SOUTHGATE TOWERS

910 WEST AVE :: MIAMI BEACH, FL 33139

910 WEST AVENUE | SGT
DRB

MODIFIED CONDITIONS

GREEN WALL DETAIL

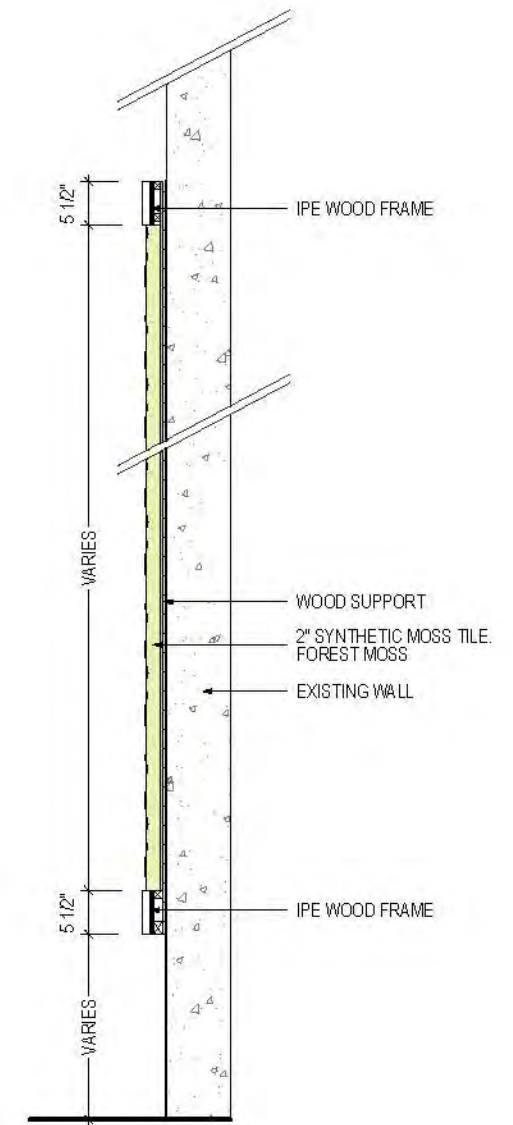
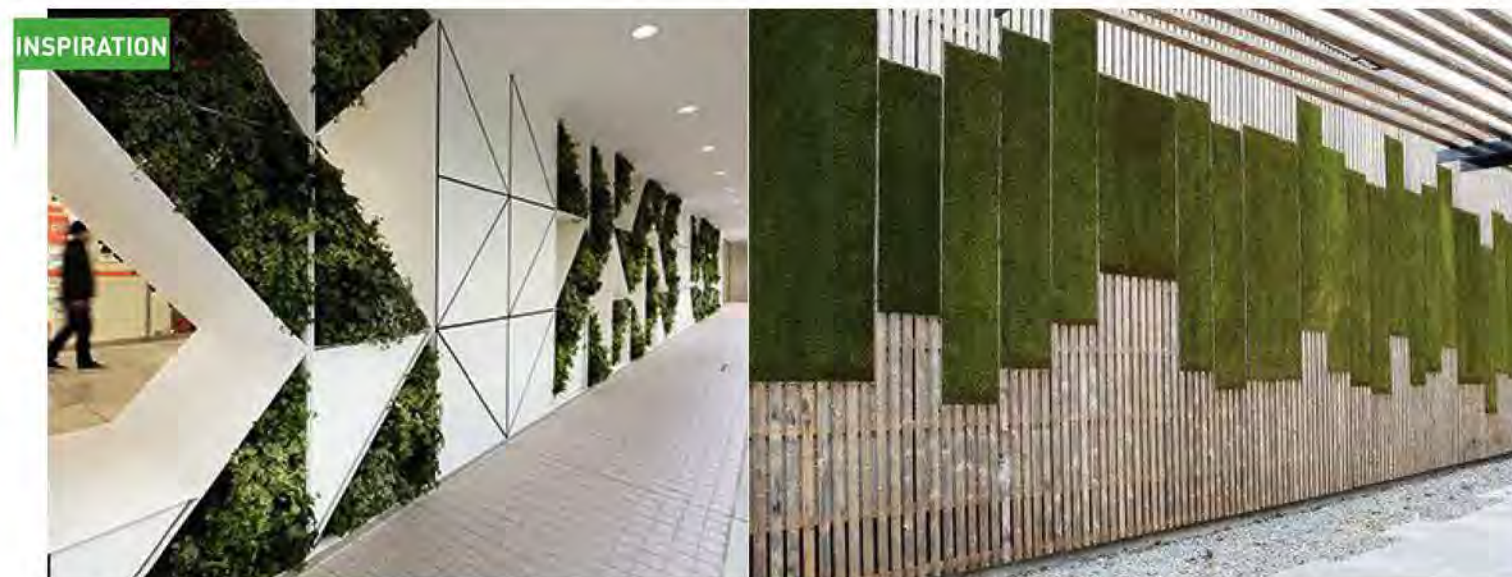
a. The artificial 'green' wall on the north elevation shall **NOT** be approved as proposed. ~~Artificial greenery shall not be permitted. The incorporation of living greenery may be permitted,~~ in a manner to be reviewed and approved by staff.

TYPICAL HANDRAIL ELEVATION

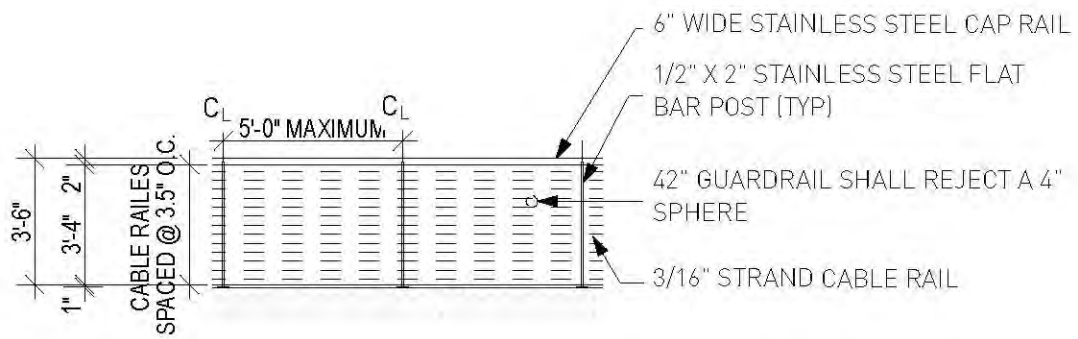
- n. Any new exterior ground floor exterior handrails and support posts shall incorporate a flat profile. The final design details, dimensions, material and color of all new exterior handrails shall be made part of the building permit plans and shall be subject to the review and approval of staff consistent with the Design Review Criteria and/or the directions from the Board.

NOTE:
HANDRAILS TO INCORPORATE A FLAT PROFILE AND ANY ACCESSIBILITY RAIL TO RETURN TO THE GROUND
